**Consultation
Persley Den, Woodside (OP135) Masterplan**

Persley Den (Woodside) OP135 Masterplan – public consultation

Thank you for consulting SEPA on the Masterplan for the above development proposal by way of your consultation e-mail which we received on 14 November 2013. We welcome this opportunity to comment on the Masterplan, Draft 2b, for Persley Den (hereby just referred to as the "Plan").

Roads Development Control
Woodside Masterplan Comments

Figure 1: GSN INFORMATION FROM ACC INTERACTIVE WEBSITE

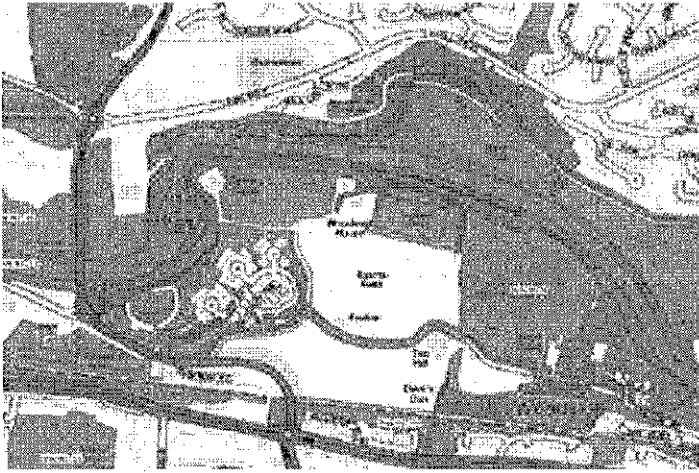
The Aberdeen Local Development plan 2012 Proposals map shows the field at the north of the development to be Green Space or Green Space Network (see Figures 1 and 2 below). Assuming that the current plan is the one printed in the Evening Express and not the master plan, I would like to question why residential housing would be permitted in this area. My concerns are on two levels:
